SUBJECT: UNIT 1 OFFSITE DOSE CALCULATION MANUAL Revision 11

OFFSITE DOSE CALCULATION MANUAL

UNIT 1

S01-ODCM
Revision 11
12-06-95

Figure 5-1

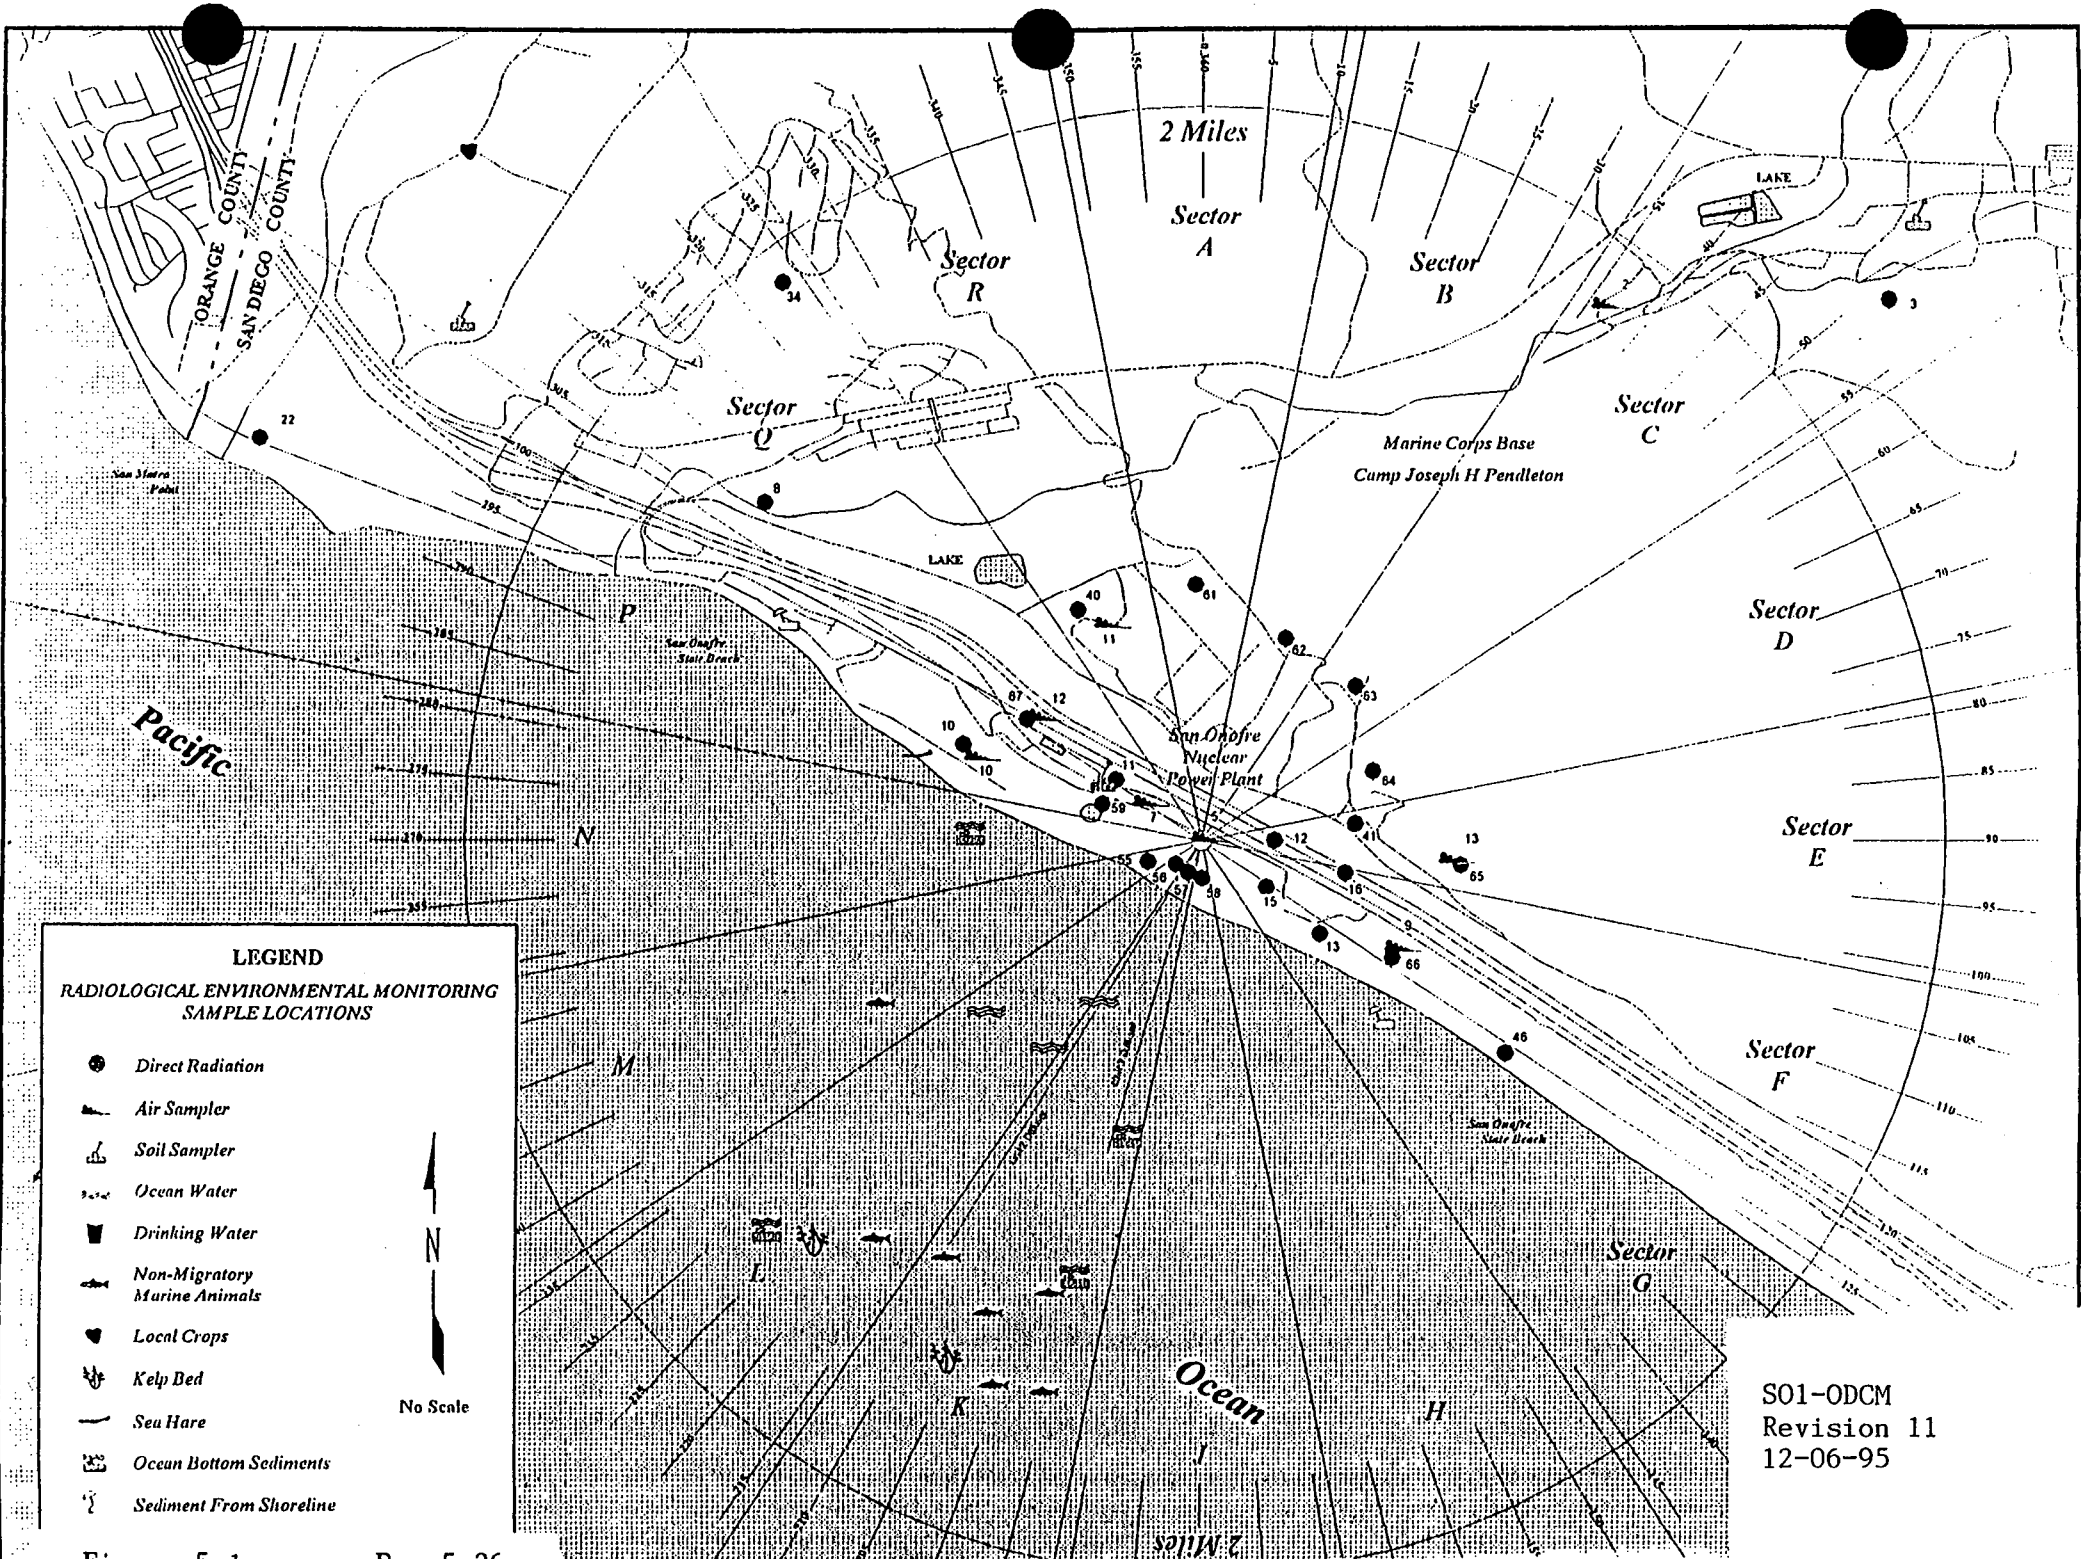
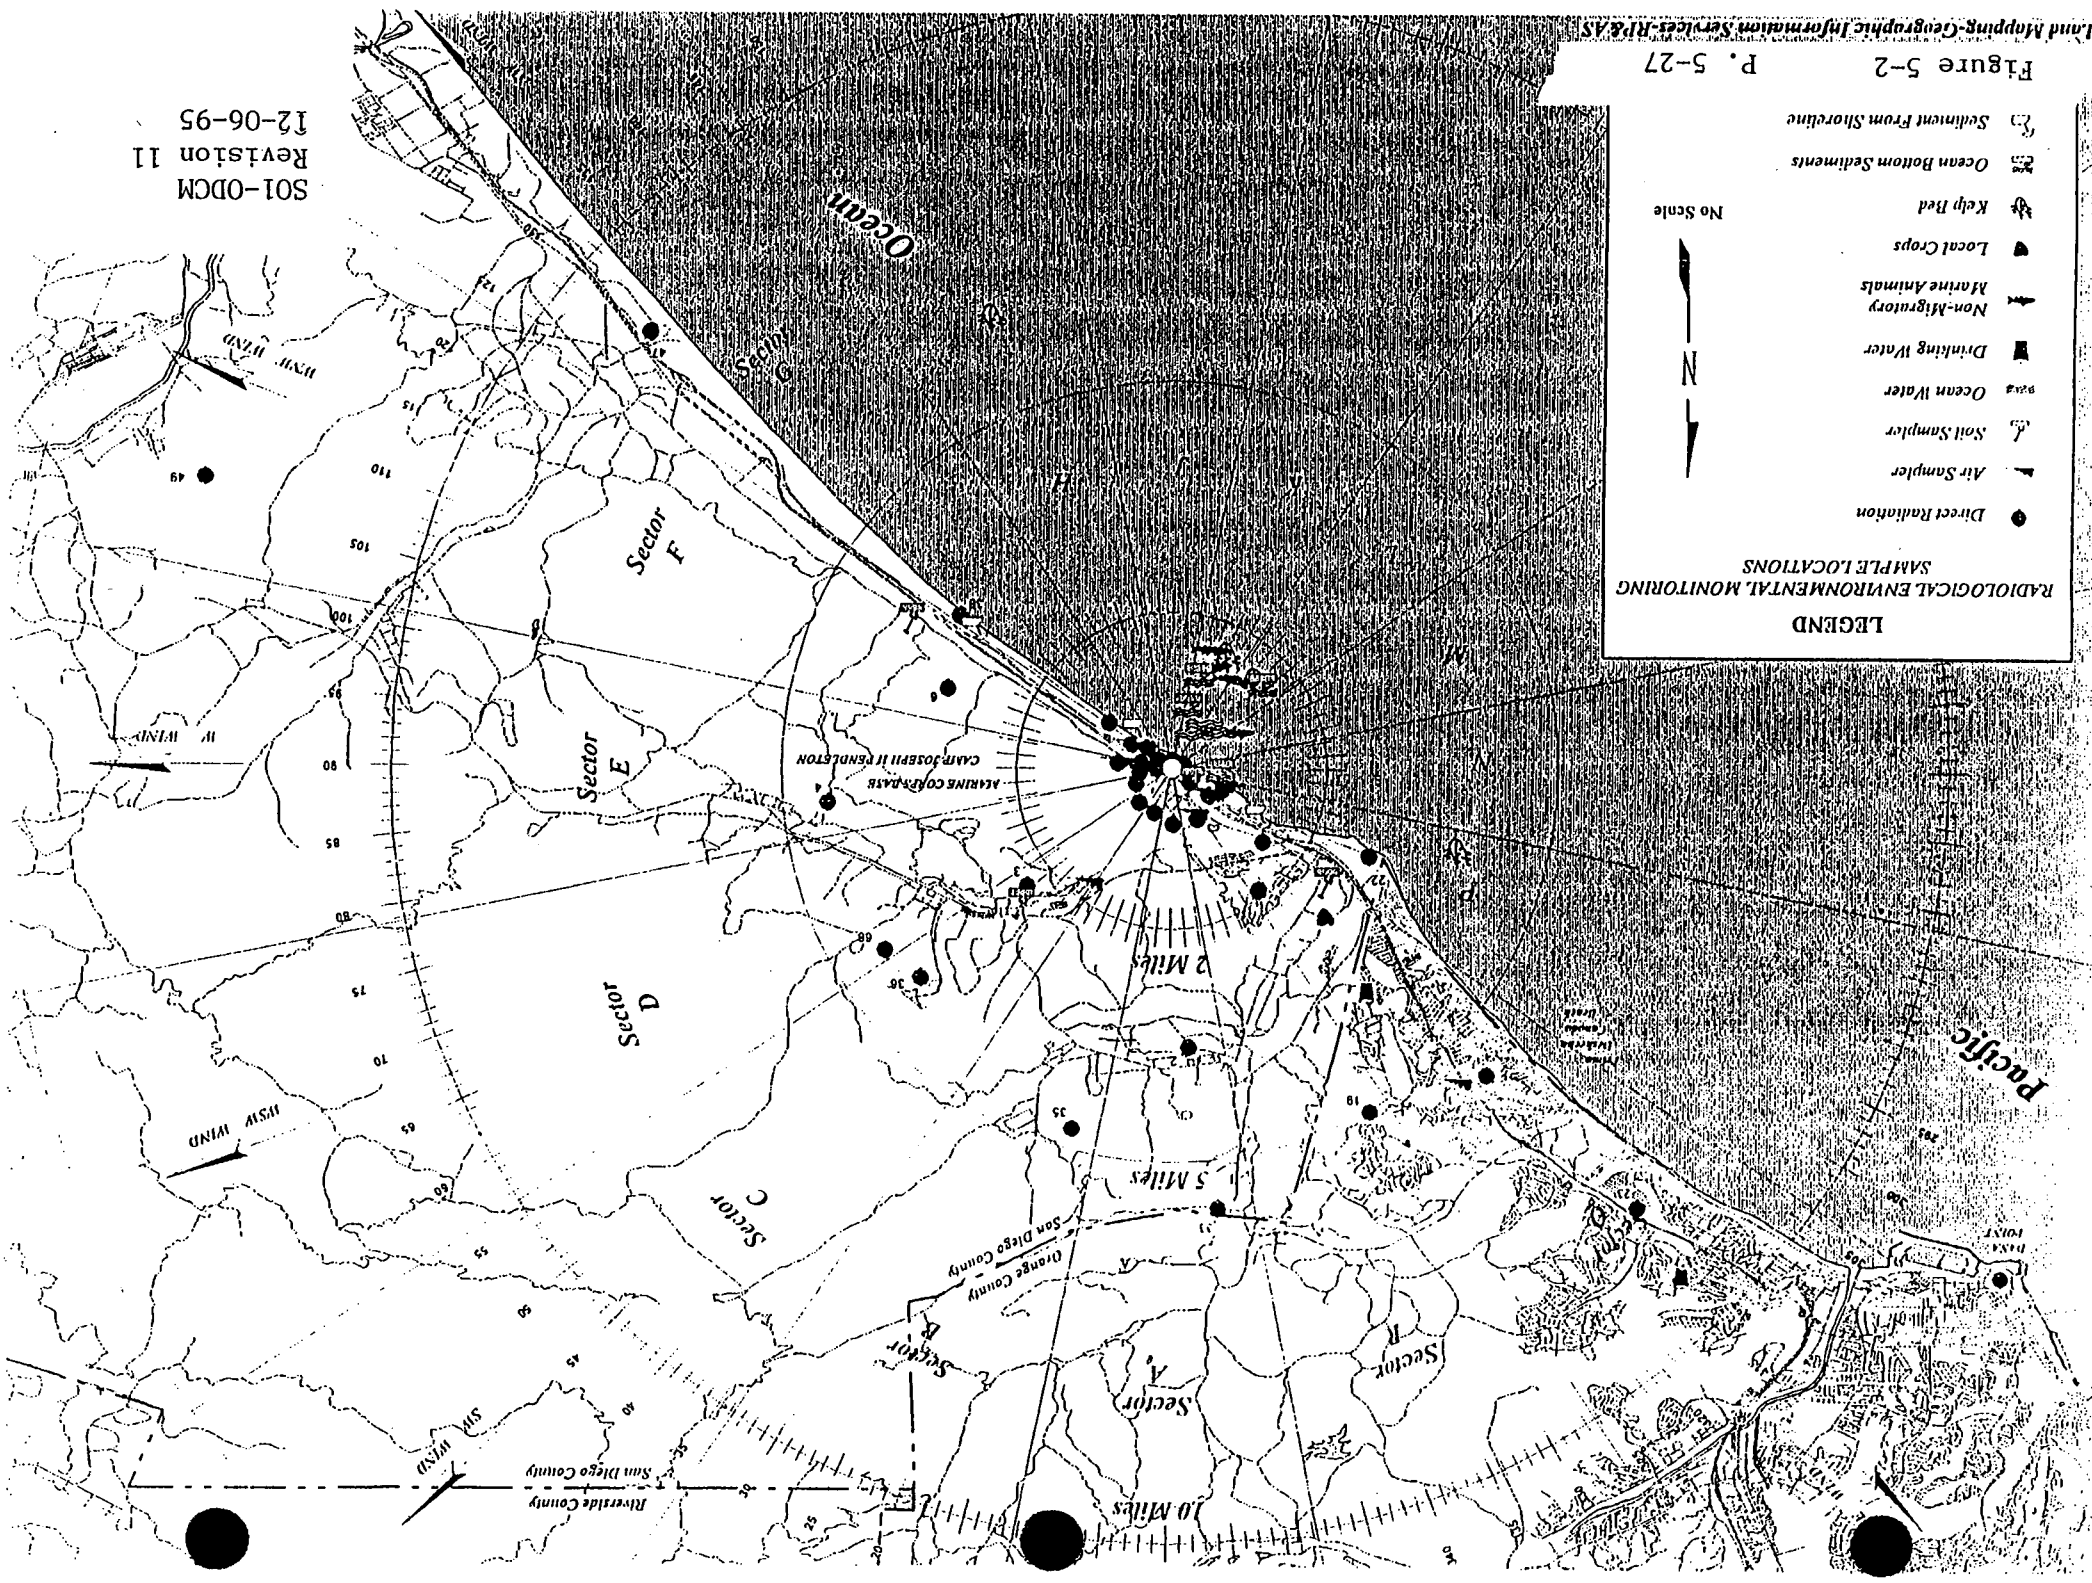
- iv Changed the word Operability to Functionality to be consistent with text of ODCM (which was revised in Revision 10) and Unit shut down condition.
- vi Replaced the previous three figures with four new figures, as supplied in the Land Use Census. The same basic information is contained in the new figures.

- 5-26- Replaced existing three figures with new versions supplied in Land Use
5-29 Census. Added a page to account for new fourth page. The same information is contained in the new figures.
